3GPP TSG CN Plenary Meeting #16
5th – 7th June 2002 Marco Island, USA.

NP-020268

Source: TSG CN WG4
Title: CR 29.002-397r3 on Check of NAM and Requesting Node Type on receipt of SendAuthenticationInfo
Agenda item: 7.11
Document for: APPROVAL

25.5.5 Process Obtain_Auth_Sets_HLR

Figure 25.5/5 (sheet 2 of 2): Process Obtain_Auth_Sets_HLR

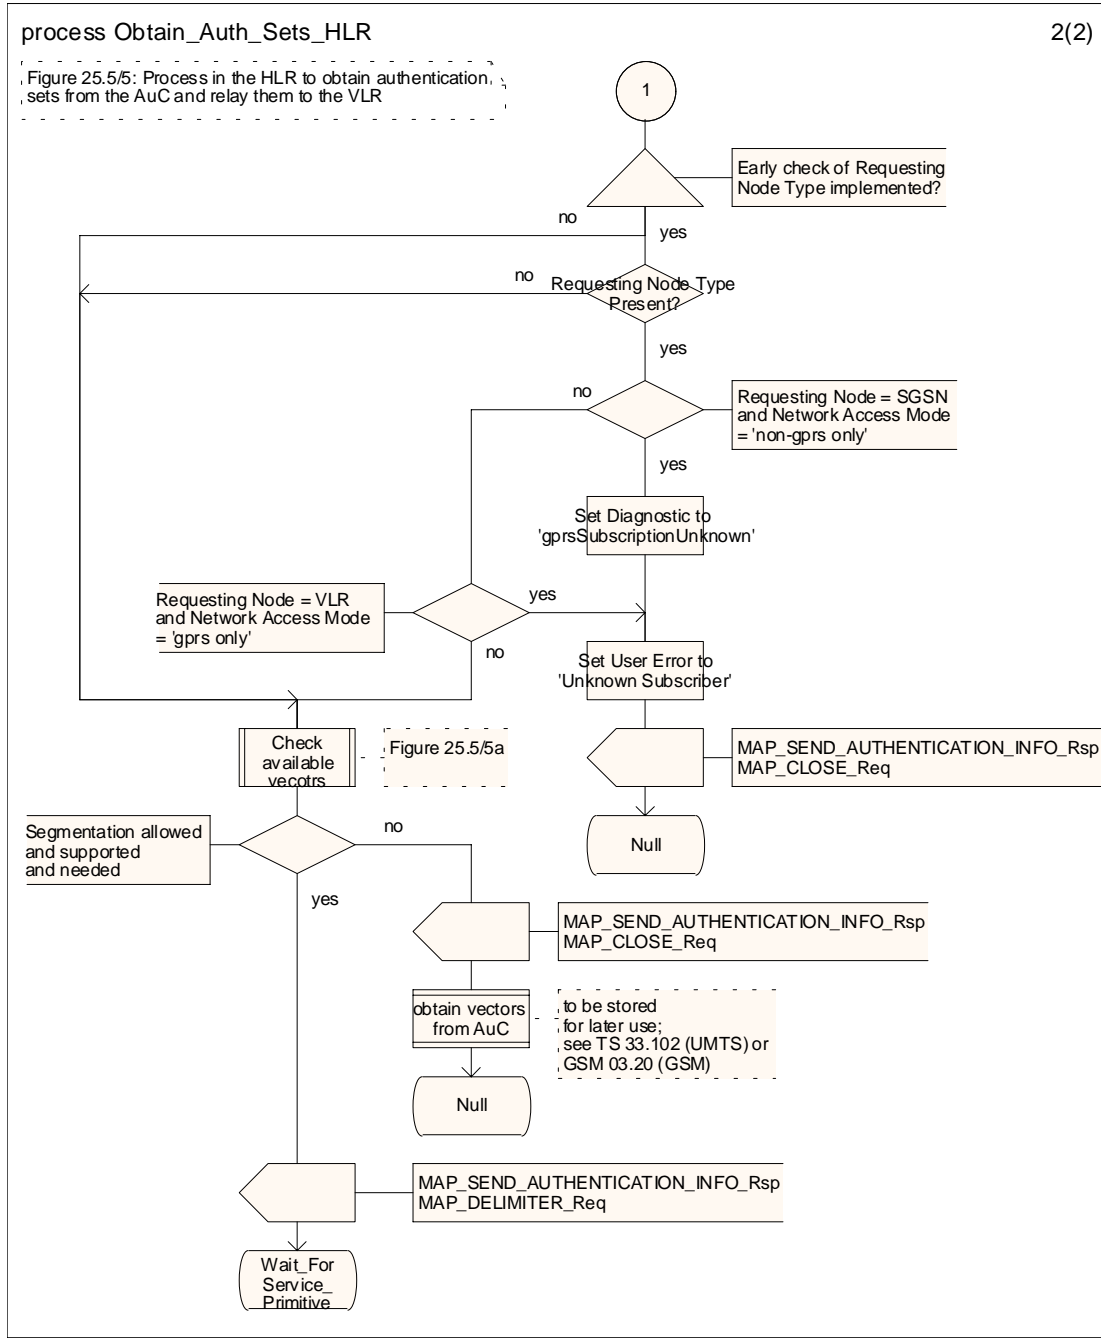
Reason for change:	⌘ Requesting Node Type parameter has been introduced in the Send Authentication Info invoke operation. To save signalling load, it would be beneficial to check that received Requesting Node Type with regard to the subscriber's Network Access Mode ('gprs-only', 'non-gprs only', 'both') in order to deny the mobile access already at authentication info request. Currently this check is done later on at receipt of the update location request.
Summary of change:	⌘ In MAP process Obtain_Auth_Sets_HLR, the SendAuthenticationInfo request is refused if the requesting node is a VLR (resp. SGSN) and the involved subscriber is 'gprs only' (resp. 'non-gprs only').
Consequences if not approved:	⌘ Un-necessary signalling load in case of authentication information request from VLR or SGSN for 'gprs only' or 'non-gprs only' subscribers.

Clauses affected:	⌘ § 25.5.5		
Other specs affected:	⌘ <input checked="" type="checkbox"/> Other core specifications	⌘ 29.010	
	<input type="checkbox"/> Test specifications		
	<input type="checkbox"/> O&M Specifications		
Other comments:	⌘ Note: The attached SDL-file contains only the second page of the process.

- If Network Access Mode is set to “non-GPRS only” and if the Requesting Node Type is present and indicates ‘SGSN’, the HLR may return error Unknown Subscriber (with diagnostic value set to “Gprs Subscription Unknown”) is returned in the response and terminate the process.

- If Network Access Mode is set to “GPRS only” and if the Requesting Node Type is present and indicates ‘VLR’, the HLR may return error Unknown Subscriber is returned in the response and terminate the process.
